# Flat 4th Floor, 31 Gloucester Avenue 2021/2291/P & 2021/2904/L

<b>Delegated Report (Members Briefing)</b>		<b>Analysis sheet</b>		<b>Expiry Date:</b>	05/07/2021
		N/A		<b>Consultation Expiry Date:</b>	18/07/2021
<b>Officer</b>				<b>Application Number(s)</b>	
Patrick Marfleet				1) 2021/2291/P 2) 2021/2904/L	
<b>Application Address</b>				<b>Drawing Numbers</b>	
Flat 4 <sup>th</sup> Floor, 31 Gloucester Avenue London NW1 7AU				Please refer to draft decision notice	
<b>PO 3/4</b>	<b>Area Team Signature</b>	<b>C&amp;UD</b>	<b>Authorised Officer Signature</b>		
<b>Proposal(s)</b>					
Enlargement of existing fourth floor roof extension with associated works including removal of front balustrade.					
<b>Recommendation(s):</b>		1) Grant conditional planning permission 2) Grant conditional listed building consent			
<b>Application Type:</b>		1) Full Planning Permission 2) Listed Building Consent			
<b>Conditions or Reasons for Refusal:</b>		Refer to Draft Decision Notice

### 3. Existing and proposed front elevation

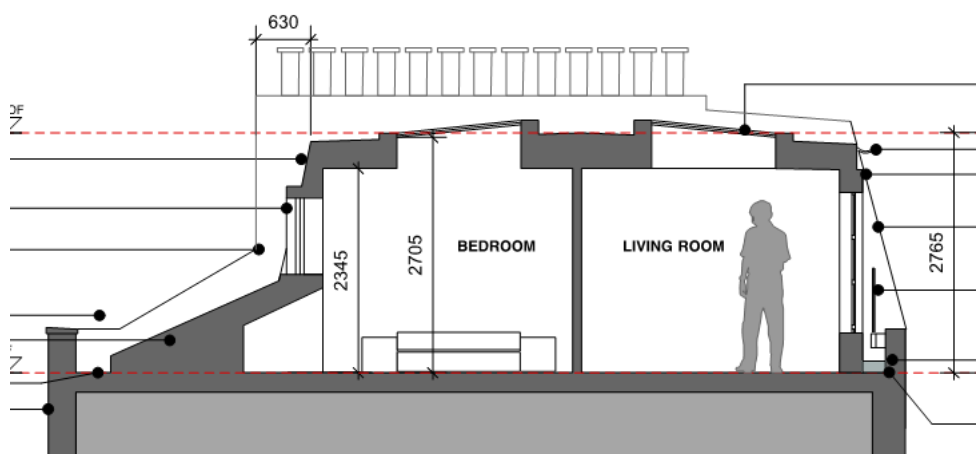
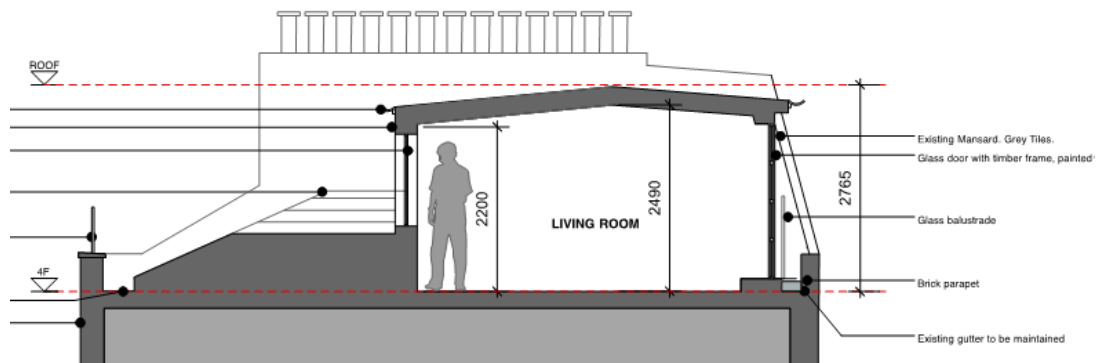
2.2.4 The current proposals would increase the depth of the existing roof extension by 1.2 metres which would result in the removal of approximately 6.8sqm of the existing roof to the front of the property. Whilst this loss of fabric is regrettable, it is considered minor and would not harm the special historic significance of the listed building as a result, particularly as a considerable section of the original valley roof would be retained. Furthermore, the alterations to the design of the proposed extension which include the cladding of the front elevation in slate tiles to match the existing roof and the installation of two equally sized dormer windows which align with the fenestration of the façade below, are considered to represent heritage benefits that would improve the overall appearance of the listed building. These benefits are enhanced further by the removal of the existing metal balustrade above the front elevation parapet, which is welcomed.

2.2.6 Officers note the concerns that have been raised by residents and the Primrose Hill CAAC regarding the harmful impact the proposed extension would have the appearance of the terrace, given it is a largely unimpaired roofscape, and the increased prominence it would have in long views from the surrounding conservation area.

## 5. Existing and proposed long views

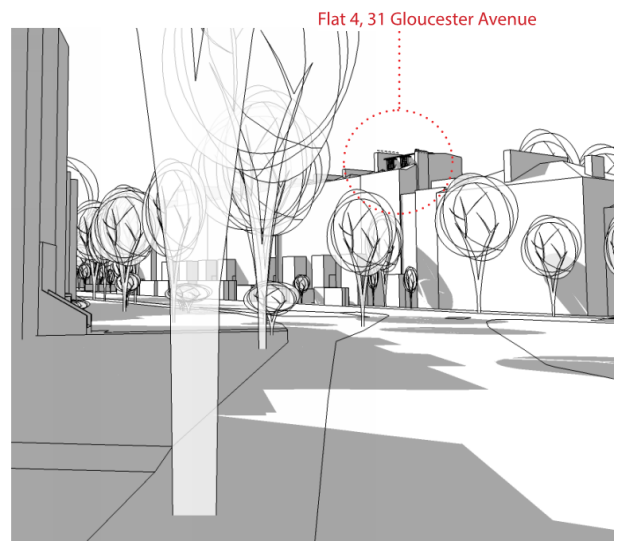
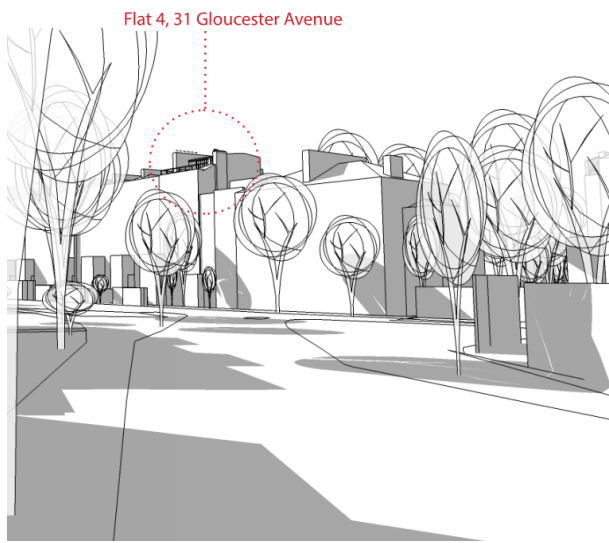
2.2.7 It is clear from the visibility studies included within the submitted DAS that the existing roof extension is already visible in long views south from Gloucester Avenue. Therefore, when compared with the proposed view from Gloucester Avenue (see site images above) it is clear that, whilst the proposed extension would cover a greater portion of the chimney stack, the increased depth of 1.2m

would not significantly increase the prominence of the extension in views from the street. As such, the proposals are not considered to cause harm to the character and appearance of the surrounding conservation area.

### Sections of previously refused applications

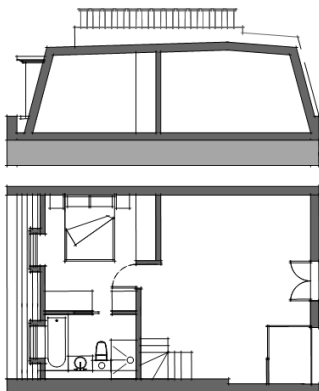
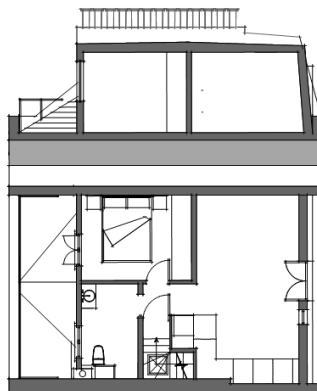
1.3 Two previous applications to enlarge the existing roof extension were submitted in 2018 and 2019 and were both subsequently refused by the Council due to the harm their increased size and prominence was considered to have on the character of the host building and surrounding conservation area. The section images included below demonstrate how the proposed extension has reduced in size from the initial 2018 app through to the current application, which is now considered to have an acceptable impact on the appearance of the host building and surrounding conservation area. The heritage impact is discussed further in section 2.2 below.
